Planning Ref: 21/01242/FUL

Solar farm for the generation of up to 40 MW of AC electrical energy, including access tracks, solar panels, transformer cabins and a substation, enclosed within a 2m perimeter 'deer' fence and associated landscaping.

Applicant Response to LLFA Comments (March 2026)

Plate 1: Slope analysis

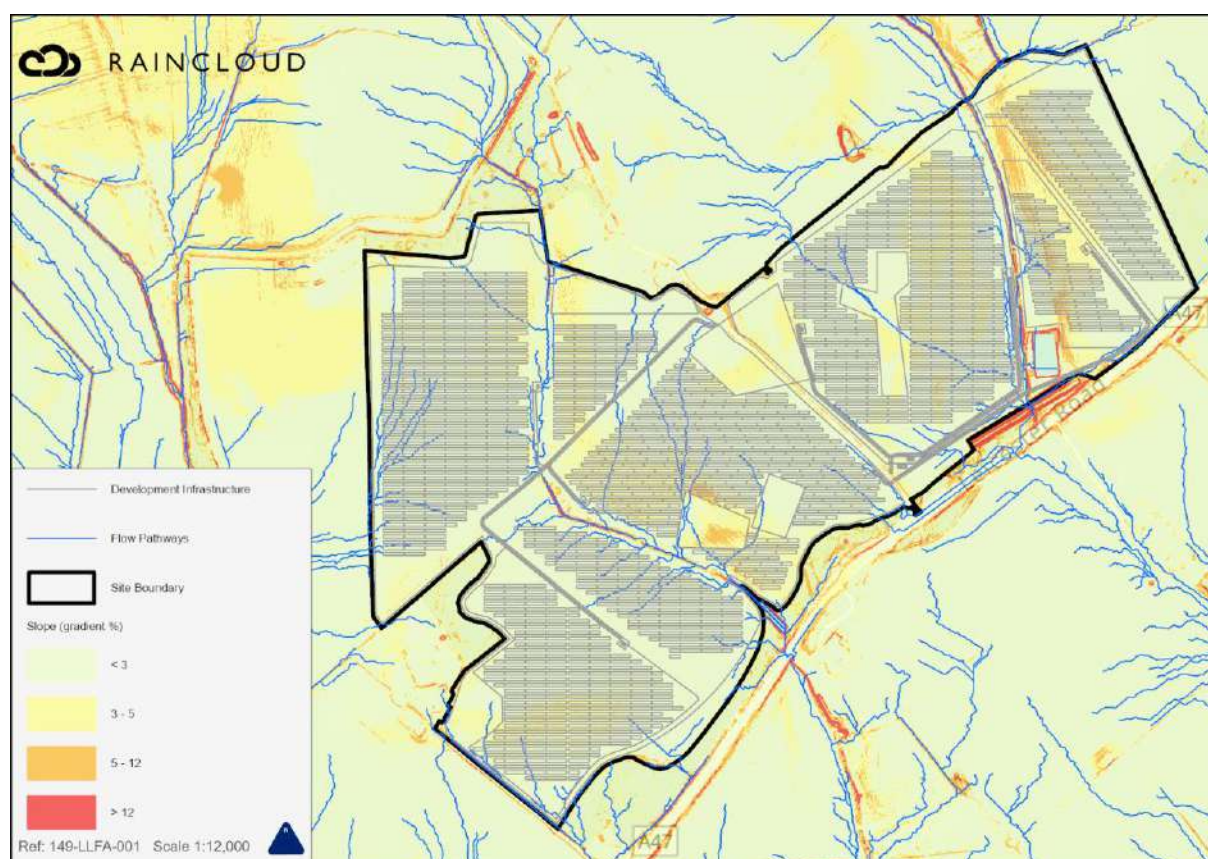
The site is predominantly located on gently sloping land (< 5% gradient) with small areas of moderate slopes (5 - 12% gradient), as shown in Plate 1. EA guidance¹ recognises runoff from gentle slopes is low therefore runoff from the development is likely to be low as well.

Surface Water Drainage Strategy

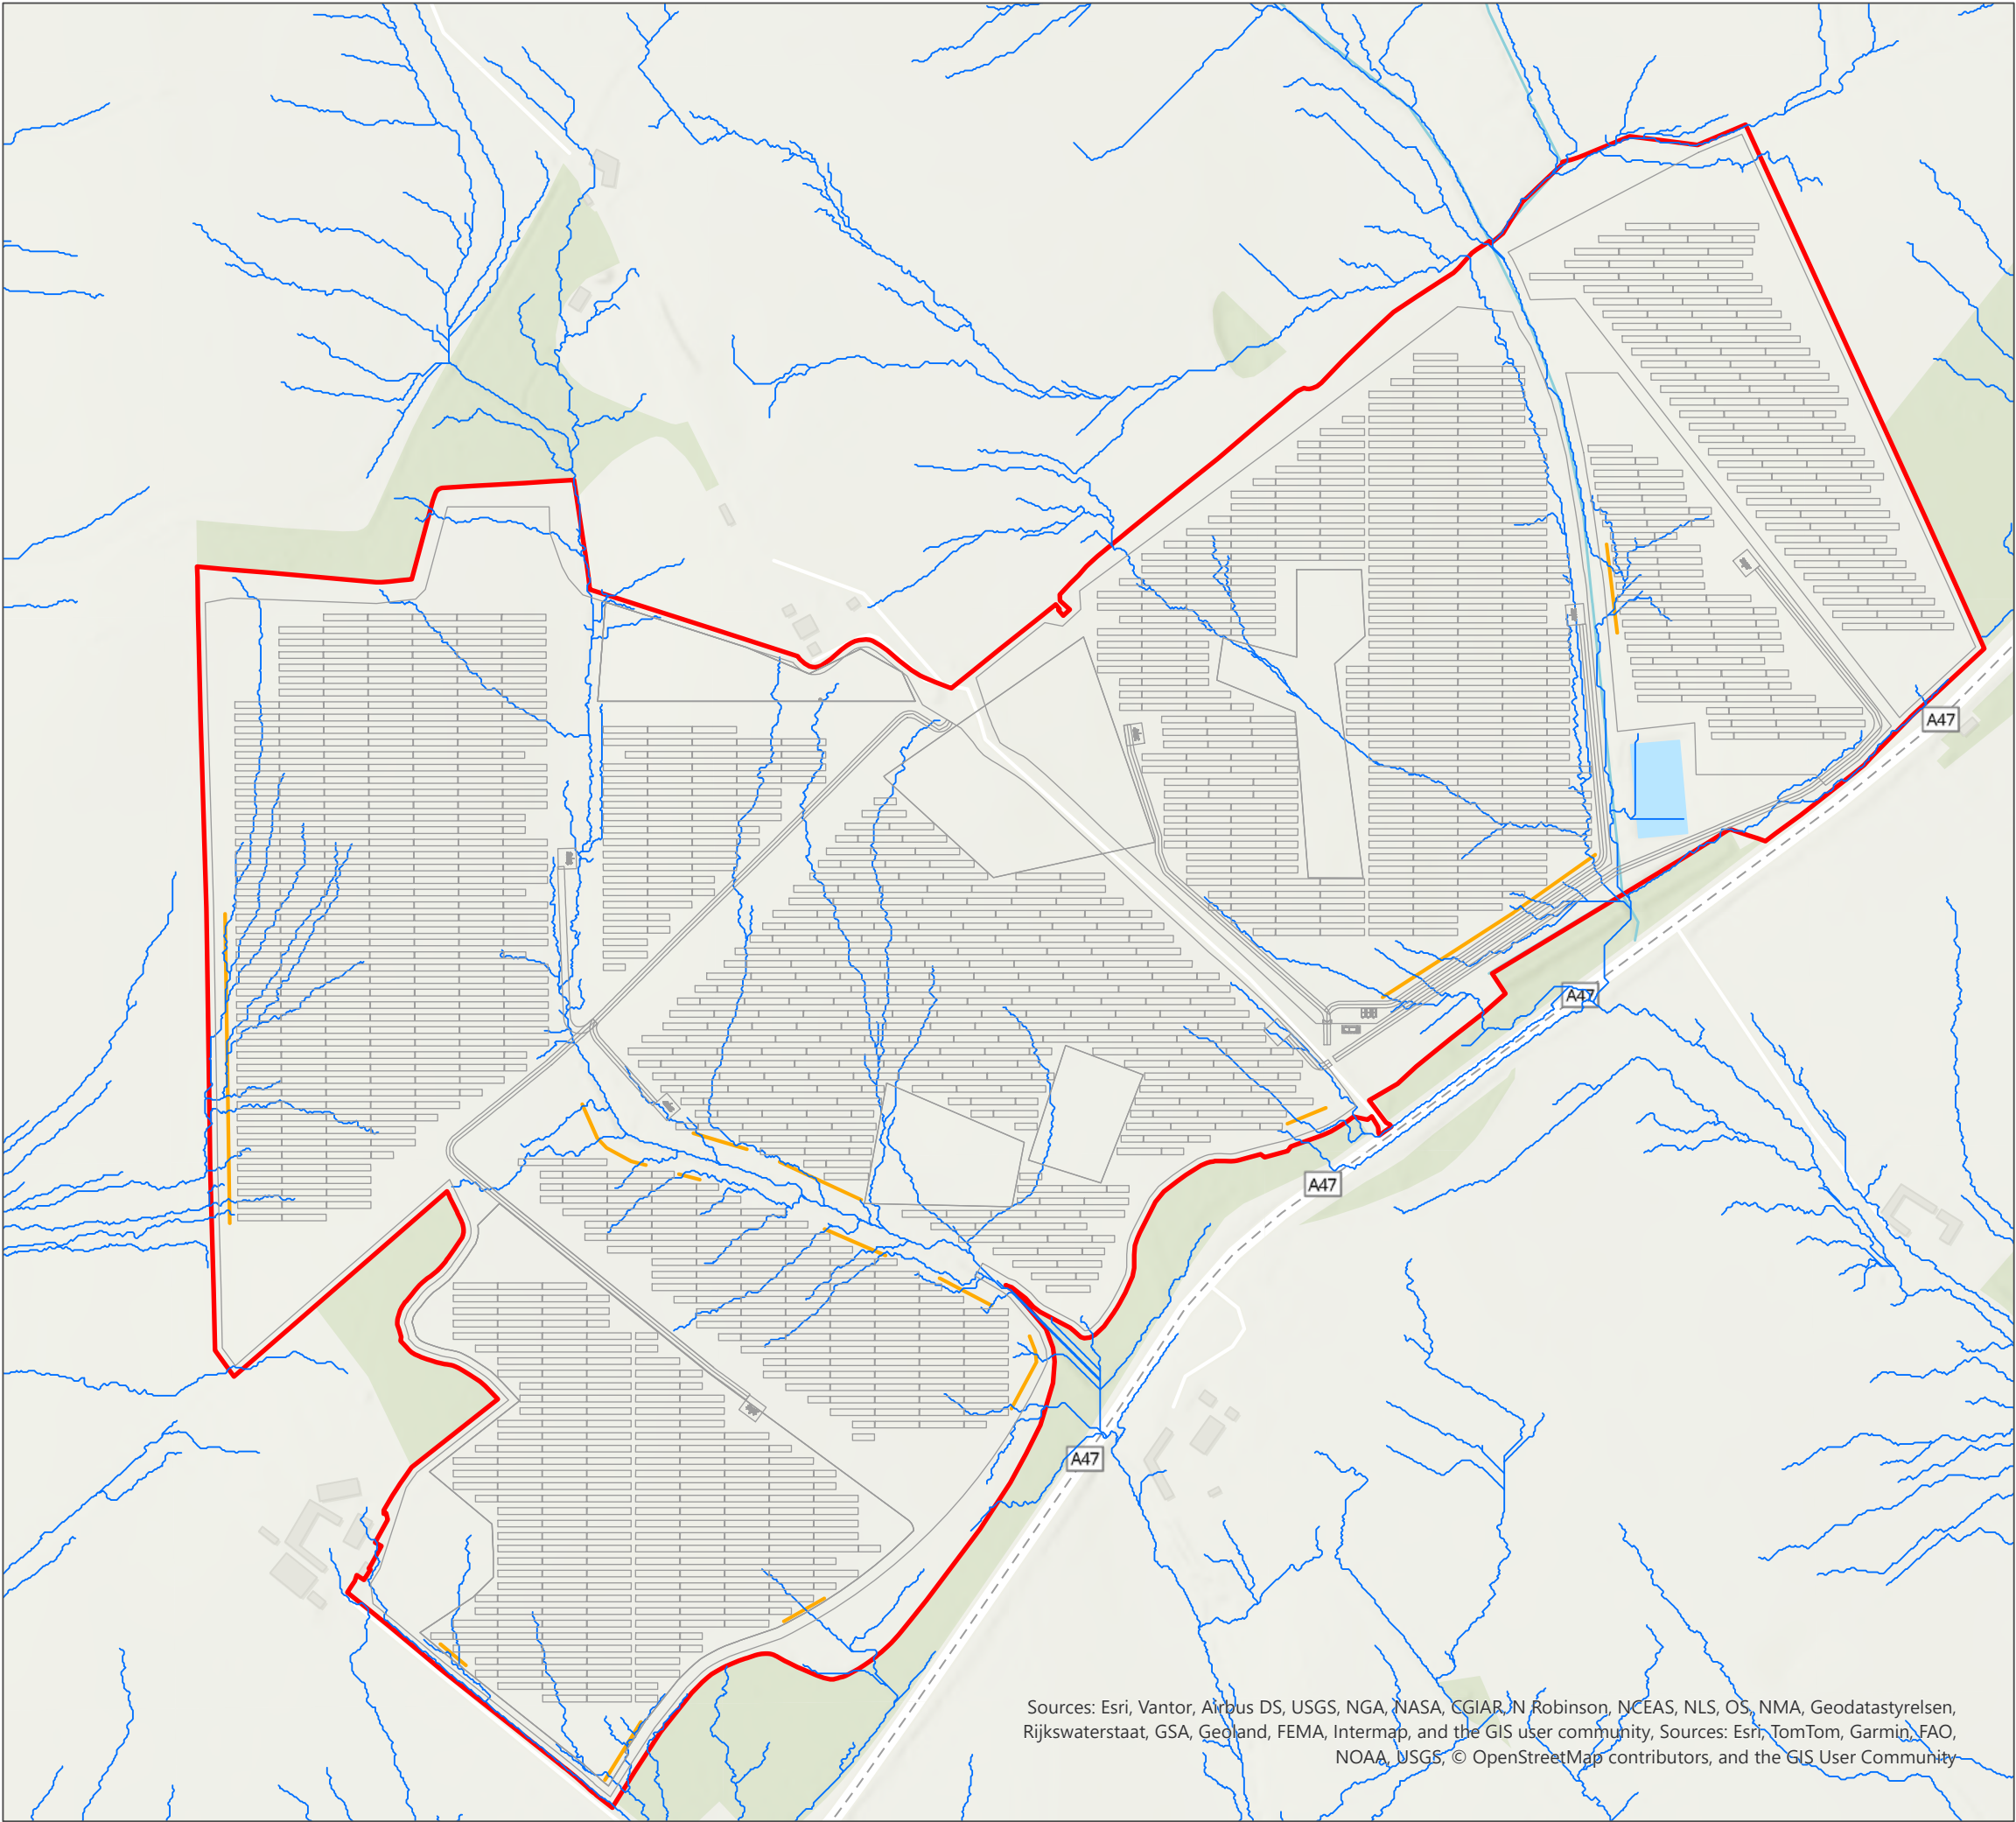
To provide additional betterment, swales will be located on key surface water flow pathways to capture runoff. The swale locations are provided in Appendix B. Swales will have an approximate surface width 2.5 m, side slope 1:3, depth 0.3 m and base width 0.7m.

The proposed surface water drainage strategy for the site aims to mimic natural processes that exist on the site. A series of swales are to be located on key flow pathways to capture runoff generated and provide a betterment than the existing scenario. The proposed drainage strategy does not utilise an infiltration basin and therefore infiltration testing is not deemed appropriate for the site.
